CONTRACT CHANGE ORDER NO. _____
SHEET ____ OF ____

MARK	DATE	DESCRIPTIONS	BY	CH'D	CCO#
2	05/07/12	SADDLE BLOCKING	GB	MN	240
1	10/31/08	TOWER HEAD DETAILS	MN	GB	93

SAN FRANCISCO OAKLAND BAY BRIDGE
EAST SPAN SEISMIC SAFETY PROJECT
SELF-ANCHORED SUSPENSION BRIDGE
(SUPERSTRUCTURE & TOWER)

TOWER SADDLE DETAILS NO. 4

ELEVATION VIEW (Looking North)
1:25

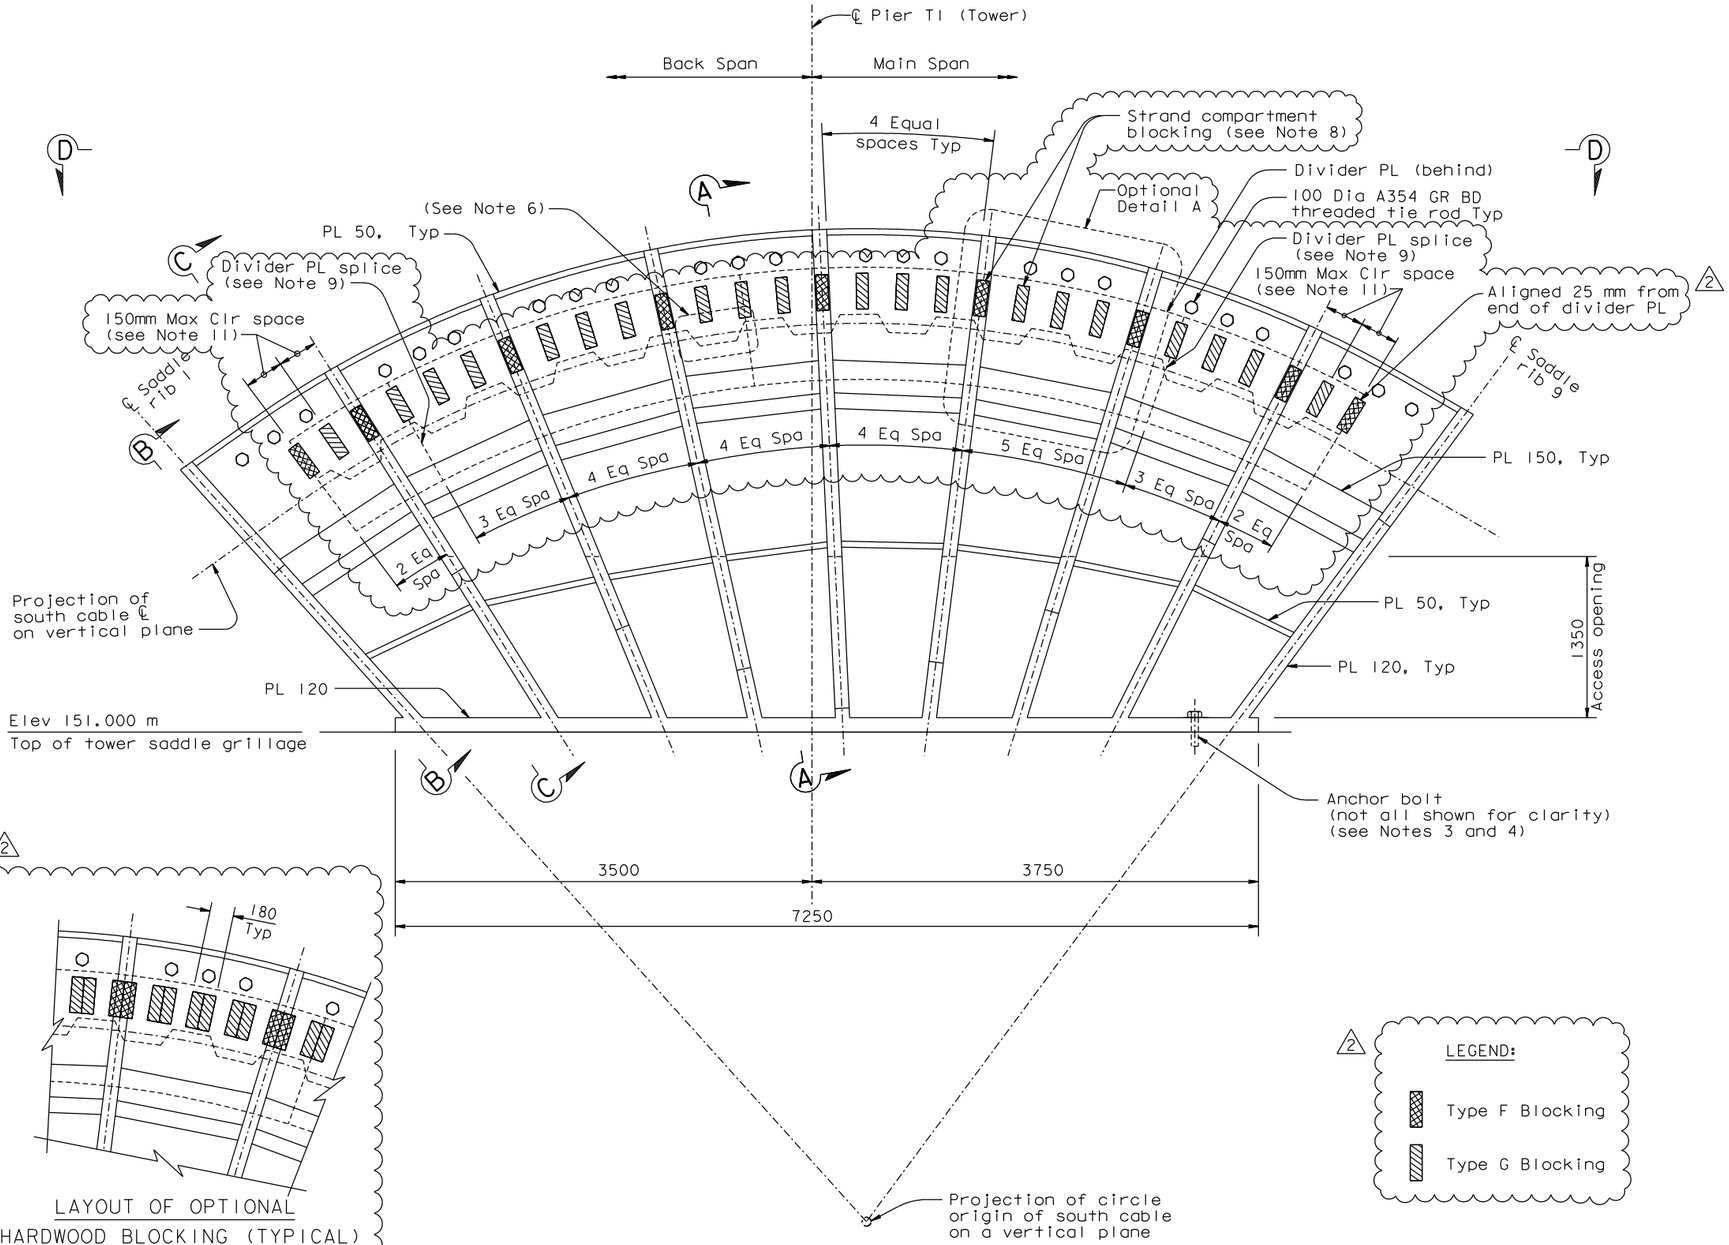
8. Contractor shall fabricate and install new blocking. For layout, see "Tower Saddle Details No.5B" sheet. For blocking details, see "Tower Saddle Details No.6" sheet.

9. The blocking shall be placed such that it straddles the divider plate spacing joint.
10. At the Contractor's option, hardwood blocking may be installed and left in place through load transfer. Hardwood blocking shall be installed in widths of 180 mm, and cut on site to fit tightly at each blocking location. After load transfer, hardwood blocking shall be left in place or replaced as directed by the Engineer.

11. Where clear distance adjacent to G blocking exceeds 150 mm, the Contractor shall install additional 90 mm wide Type G blocking in the space.
